SUBJECT: **ADDENDUM #3 TO THE BIDDING DOCUMENTS FOR:
NORTH & SOUTH HIGH SCHOOL BID GROUP #5 Phase B**
MASTER FACILITY PLAN IMPLEMENTATION
COMMUNITY HIGH SCHOOL DISTRICT 99
NORTH HIGH SCHOOL
4436 MAIN STREET
DOWNERS GROVE, IL 60516

Bid Question/Answer Log No. 1

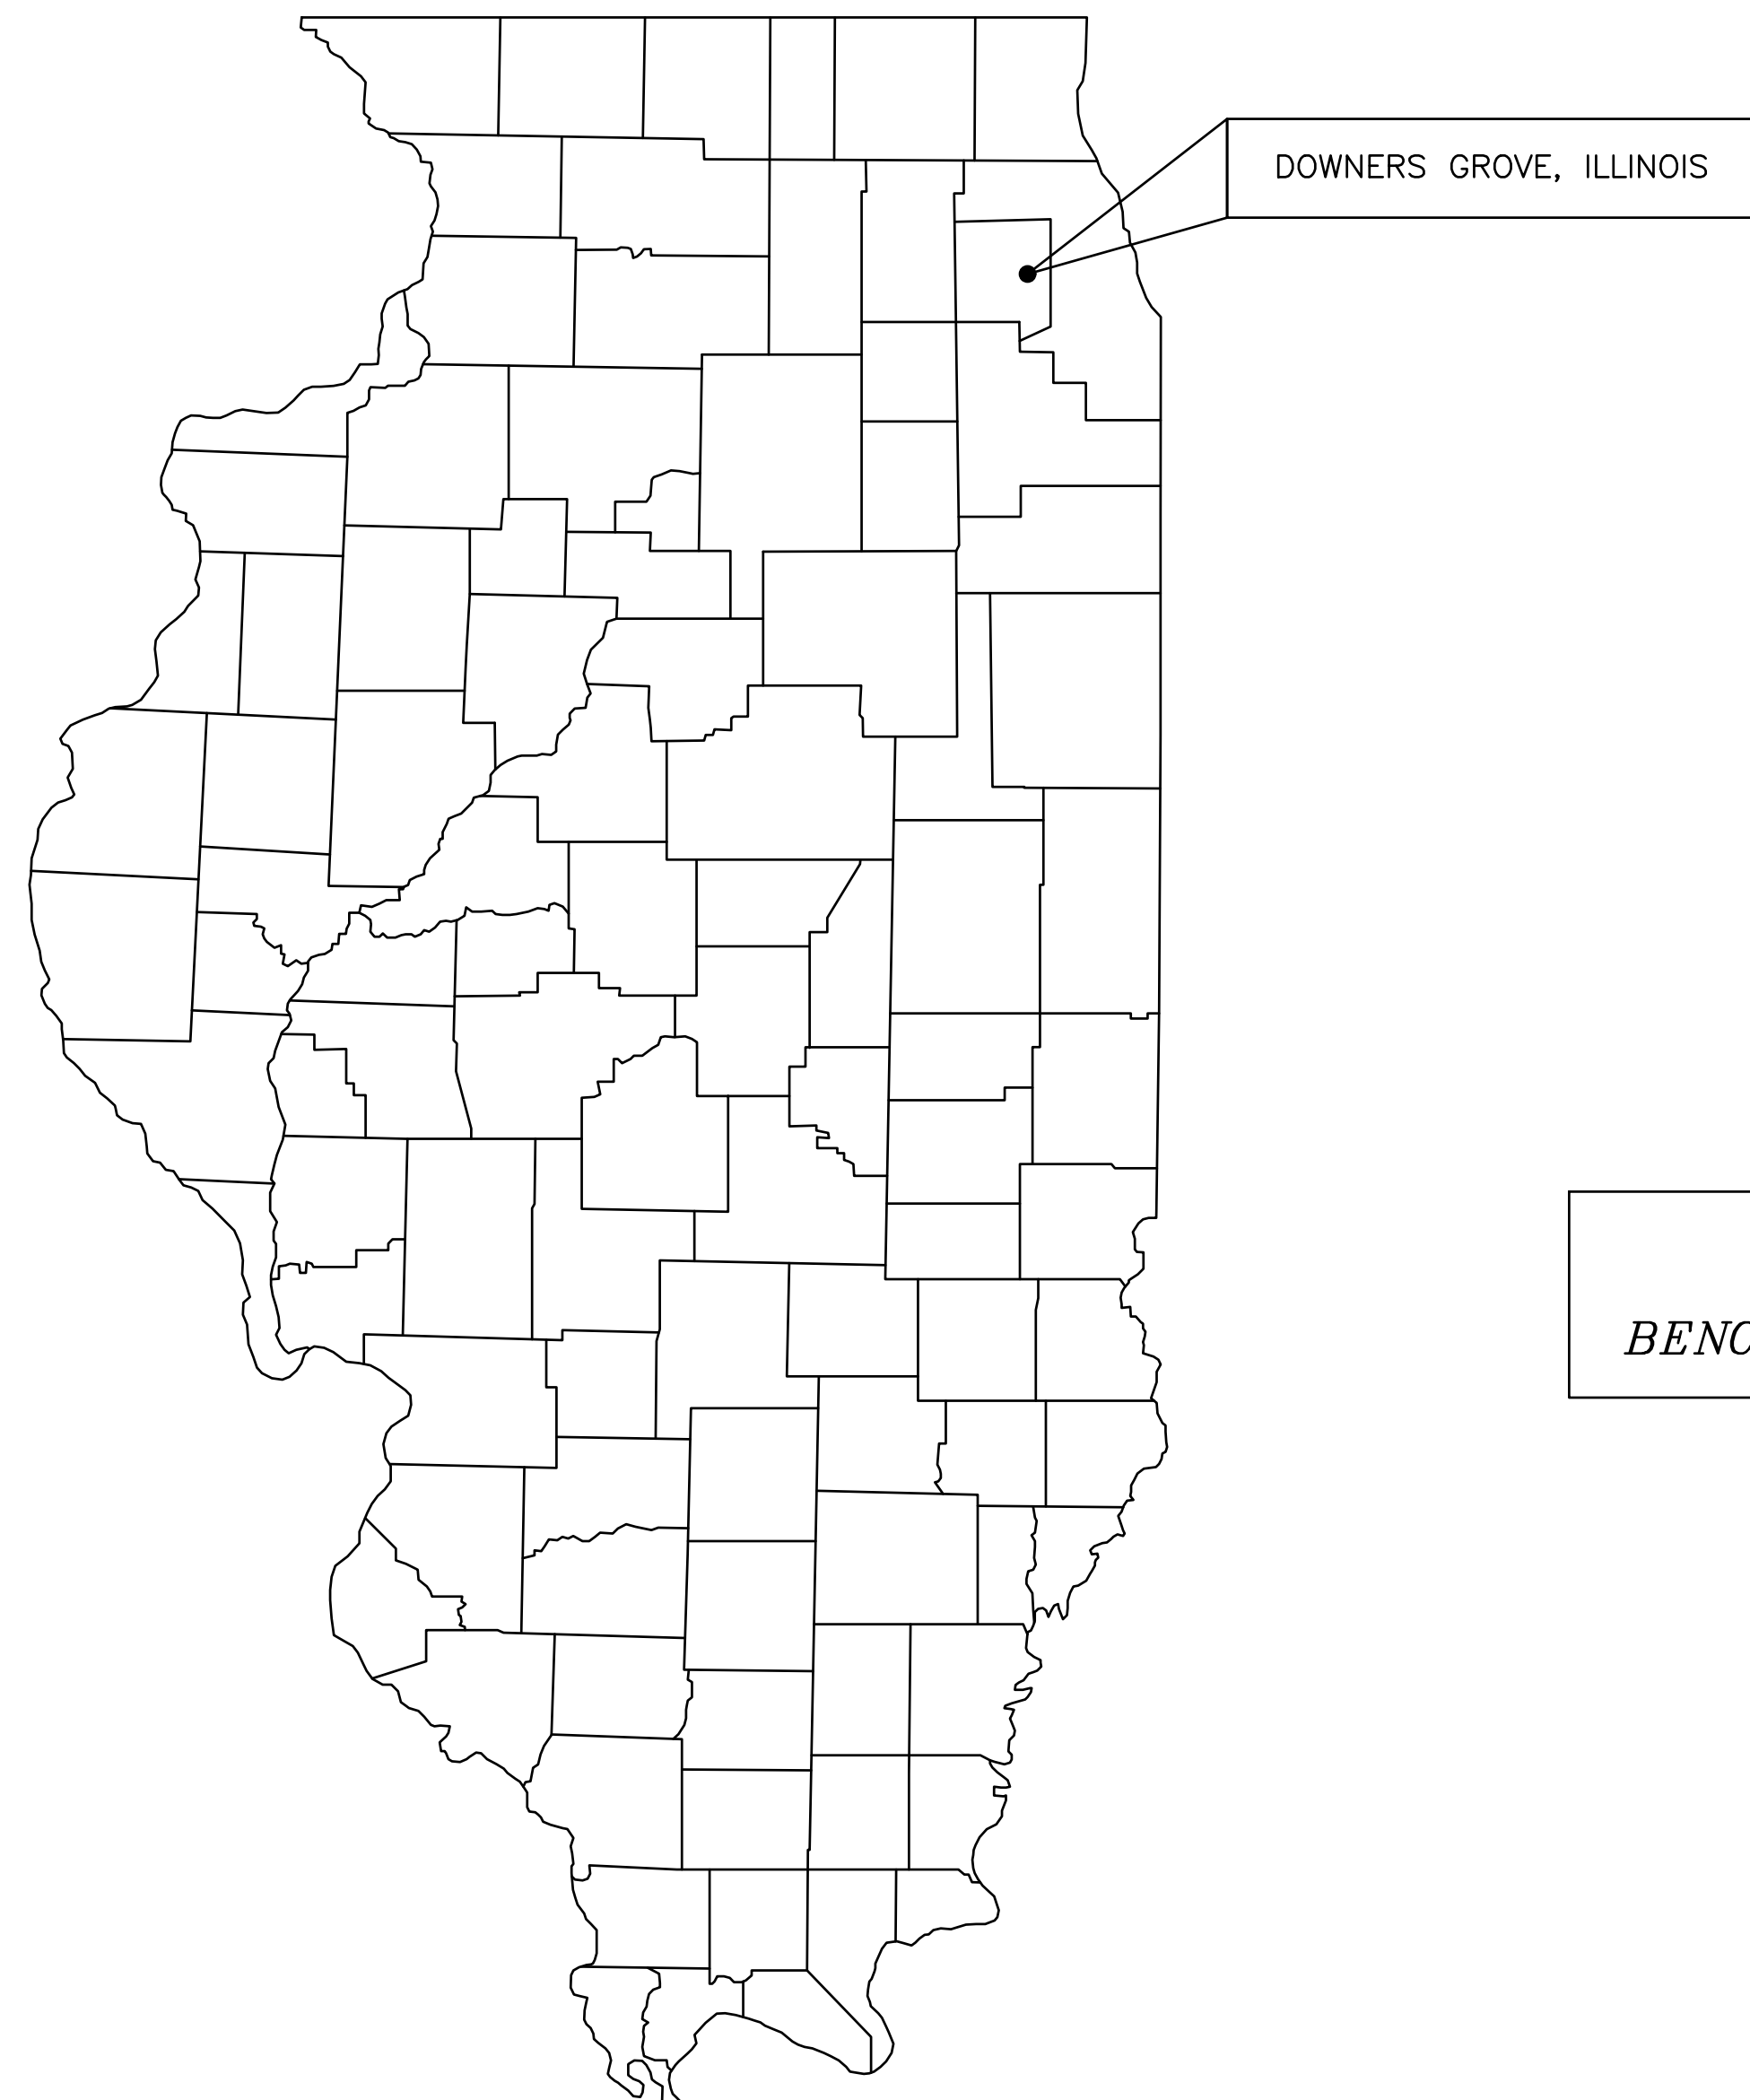
35.	Is the bleacher contractor's scope published? I know he has the complete press box. Is the bleacher contractor doing the siding, flashing, and aluminum soffits?	9-18-19	Bleacher contractor is providing press box and all metal panel enclosure, soffits, flashing. The general trade package is everything inside the side rooms including insulation.	NAS 9-18-19
